SERVICE LETTER 234

Trimming of Fire Boss Interconnect Assembly

Aircraft Makes/Model(s):	Float Model(s):	Compliance: Optional	By: MAB
Air Tractor AT-802 & AT-802A	10000A	Part Number: 1011928	Approved: SDW
		Date: 5/2/2022	Revision: B

Figure 1

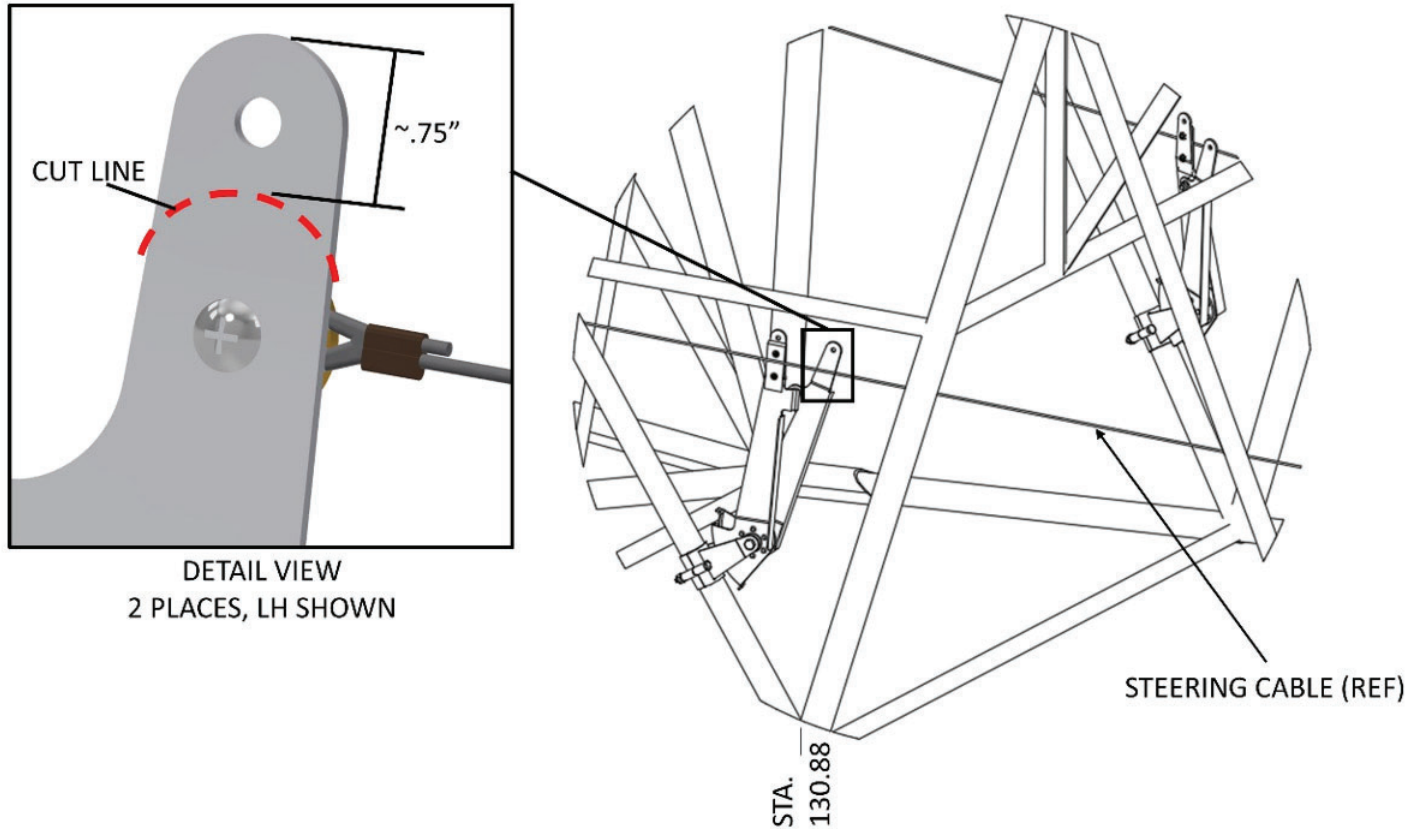
1. Gain access to the interconnect assemblies and trim approximately 0.75" from the top of each aft arm. Do not interfere with the cable and hardware below (remove these items as needed while cutting). See Figure 1.

2. Curve and smooth any sharp corners or edges.
3. Prime and paint the cut edges.
4. Reinstall aircraft panels.

Figure 2

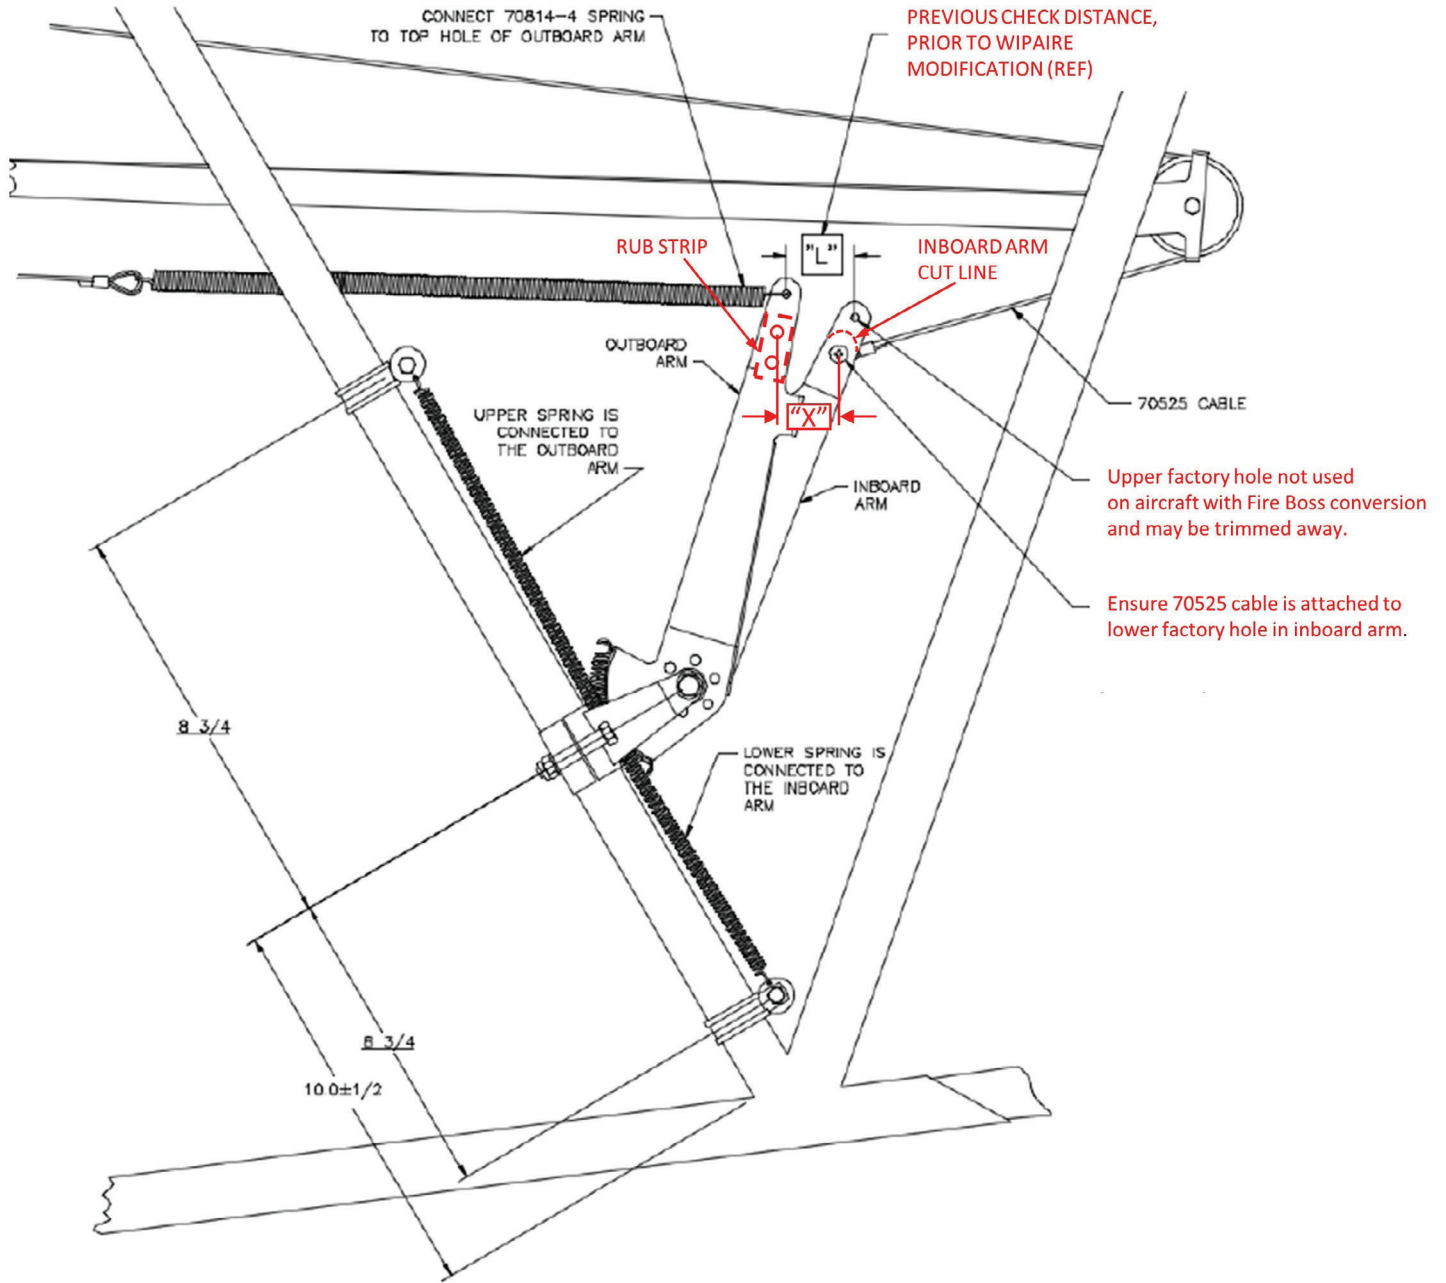
6. Ensure that the 70525 interconnect cable is connected to the lower factory hole in the inboard idler arm. See figure 2.

10. Measure the horizontal spread of the idler arms using the lower factory hole* in each arm, shown as dimension "X" in Figure 2. This dimension should measure between 1.577" and 1.690" (approximately 1-37/64 to 1-11/16 inches). In addition, both sides must match within 1/16 inches.

Note: The position of this cable attachment originally varied with the serial number of the aircraft, but all airframes eligible for Fire Boss conversion will have this cable connected to the lower hole. Additionally, the upper factory hole may have been trimmed away during float installation or as a result of this service letter.

- a) Outboard arm: The Wipaire rub strip on the outboard arm makes use of the lower factory hole and adds a third, lower hole. The "lower factory hole" is therefore the middle hole of the three.

- b) Inboard arm: The upper factory hole in the inboard arm is removed as a result of the modification described in the "Work Instruction – Modify Interconnect Assembly" section, making the "lower" factory hole the only remaining hole once this alteration is performed.

Figure 3 – Rudder-Aileron Interconnect Turnbuckles (under cockpit looking forward)

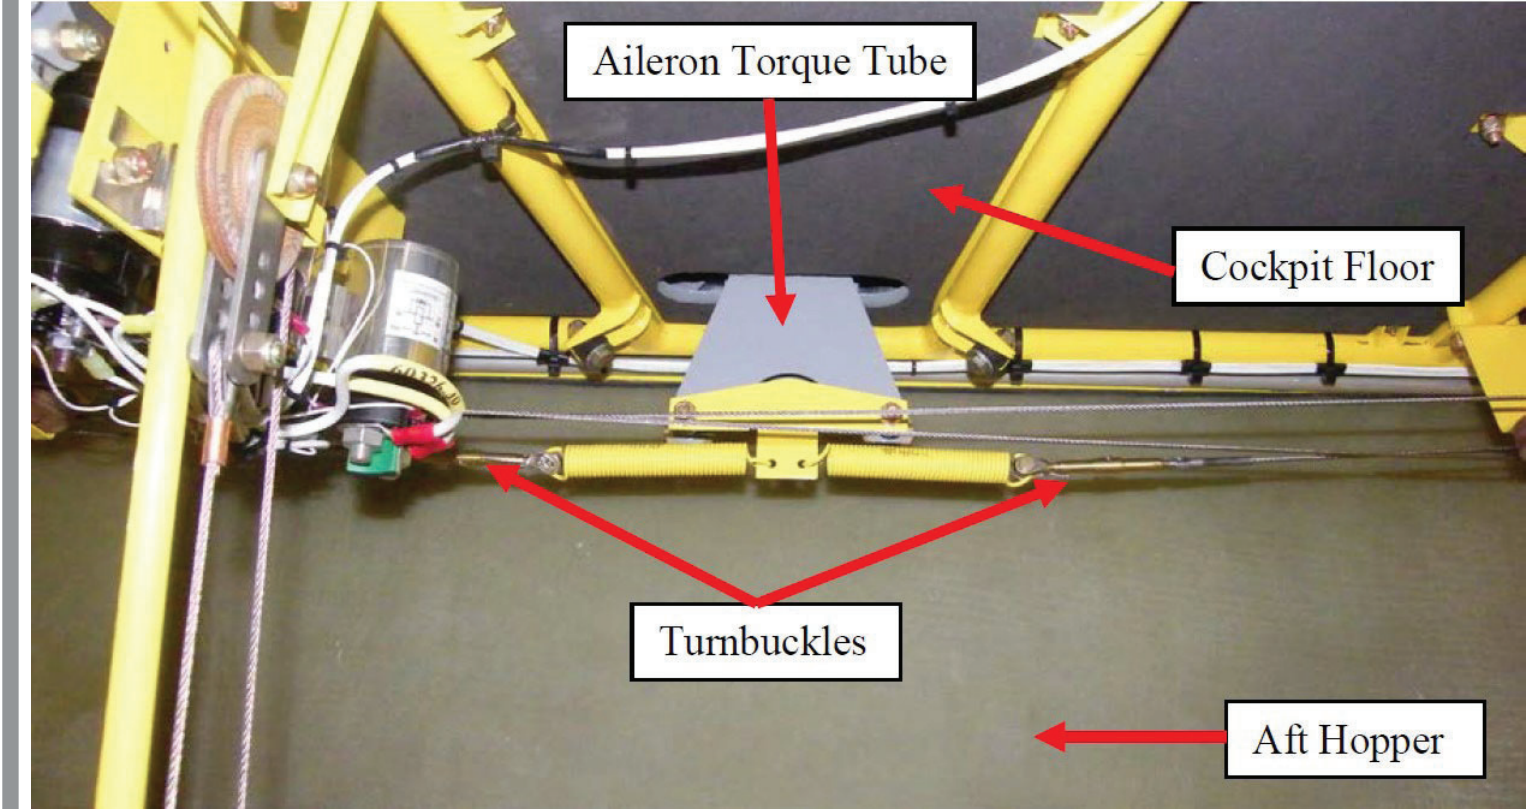
11. If necessary to match the dimension stated in Step 9, adjust the turnbuckles on the cables. See Figure 3. After adjusting, safety the turnbuckles with MS20995C32 wire (Reference: FAA Advisory Circular 43.13-1B).
